CNL-22-075

Browns Ferry Nuclear Plant, Unit 2  
Renewed Facility Operating License No. DPR-52  
NRC Docket No. 50-260

Subject: **Response to Request for Additional Information Regarding Browns Ferry Nuclear Plant, Unit 2, Request for Alternative, BFN-21-ISI-02, Alternative to American Society of Mechanical Engineers, Boiler and Pressure Vessel Code, Section XI, Paragraph IWB-2420(b) and the Use of Case N-526 (EPID L-2022-LLR-0008)**

Response to NRC Request for Additional Information

Figure 6. Development of BFN Plant-Specific Proximity Rule

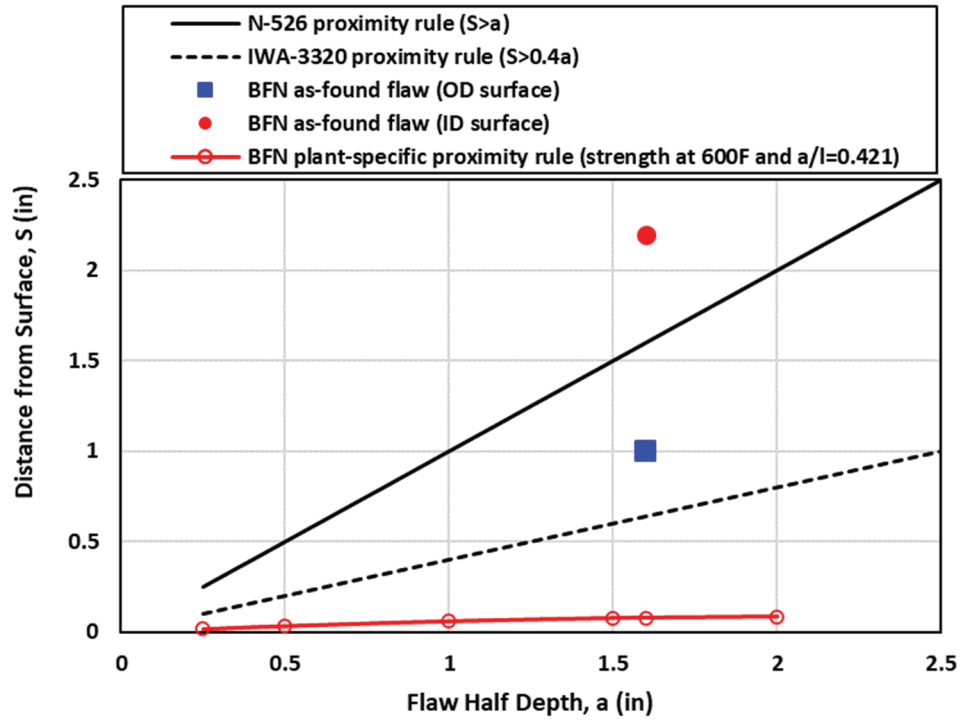
*In Attachment 1 of the proposed alternative, the plant-specific assessment states, "The Service Level A/B RPV transient in Table 4 of Reference [12] with the highest  $\Delta T$  was chosen as the bounding transient which is the Start-up Transient."*

*The NRC staff notes that the Browns Ferry Final Safety Analysis Report (FSAR), Appendix C, "Structural Qualification of Subsystems and Components," describes the basic structural loading criteria and qualification methods used in the original design of BFN, Unit 2, components and piping subsystems. These conditions include normal, upset, emergency, and faulted loading conditions. Furthermore, the staff notes that these loading conditions are the equivalent to the ASME Code, Section III, Level A, B, C, and D service limits. Based on the above statement in Attachment 1 of the proposed alternative, the staff is not clear if loading conditions applicable to service levels C and D were considered in the licensee's analysis provided in the submittal.*

*Discuss the applicability of all service loadings (i.e., normal, upset, emergency, and faulted) and any combination of them that were taken into consideration in the licensee's analysis in the submittal. Discuss whether loading conditions applicable to service levels C and D were considered in the licensee's analysis. If not considered, provide a justification for not considering the loading conditions applicable to service level C and D in the analysis in the submittal.*

As noted in the staff's question, the ASME Code, Section III, service limits A, B, C, and D are equivalent to the loading conditions described in the BFN Updated FSAR. For simplicity, this response will use the ASME service limits. According to the technical basis document of ASME Code Case N-526, only primary membrane and bending stresses are required to be included to develop the plant-specific proximity rule, and secondary stresses due to thermal transients and weld residual stresses are not required. Therefore, the licensee's original analysis considered service level A/B loading conditions to develop the plant-specific proximity curves. Because the as-found flaw is an axial flaw type, bending and axial stresses from service level C/D loadings such as safe shutdown earthquake and loss of coolant accident do not contribute to the crack driving force. Only membrane hoop stress (due to pressure) contributes to the crack-driving force. An additional plant-specific analysis was performed in Enclosure 3 for service level C/D loadings using the same methodology as the technical basis of ASME Code Case N-526 with the plant-specific material properties, operating stress (only internal pressure for service level C/D loadings), and as-found flaw aspect ratio to develop a site-specific proximity curve.

The results of the analysis in Enclosure 3 demonstrate that the plant-specific surface proximity curves for service level C/D loading is slightly higher than that for service level A/B loading (due to higher internal pressure for C/D loadings). However, each of these curves falls below both the IWA-3320 proximity rule and the Code Case N-526 surface proximity rule. Because the as-found flaw must meet the requirements of IWA-3320 to be considered as subsurface, the IWA-3320 rule ( $S > 0.4a$ ) would be the plant-specific proximity rule for the as-found flaw under both service level A/B and C/D loadings.

Because the plant-specific proximity curve remains applicable for both service level A/B and C/D loadings and the as-found flaw is bounded by the plant-specific proximity rule (i.e., above the IWA-3320 curve), it meets the intent of the requirements of ASME Code Case N-526 to exempt the successive re-examinations required by IWB-2420(b), ensuring an acceptable level of performance and safety.

Figure 4: Stress Intensity Factor Comparison - Quarter-T Flaw Versus Weld V-3-A Flaw

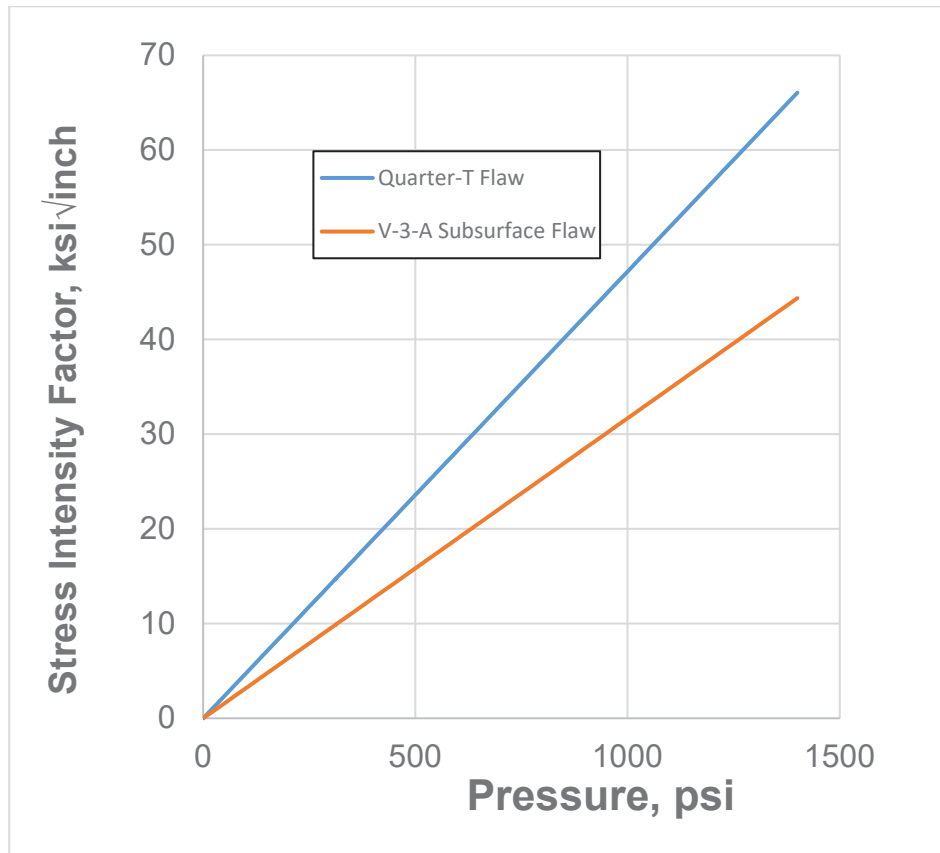
*TVA has not indicated if the flaw in weld V-3-A affects the P-T limit curves.*

*Discuss whether the flaw in weld V-3-A affects the existing P-T limit curves in the plant technical specifications. If yes, indicate when TVA plans to revise the P-T limit curves to reflect the impact of the flaw on the P-T limit curves in the technical specifications via a separate license amendment request.*

Figure 4 shows the comparison of the Stress Intensity Factors for the two flaw types as a function of pressure. It is seen that the K<sub>I</sub> solution for the Appendix G flaw bounds that for the weld V-3-A indication.
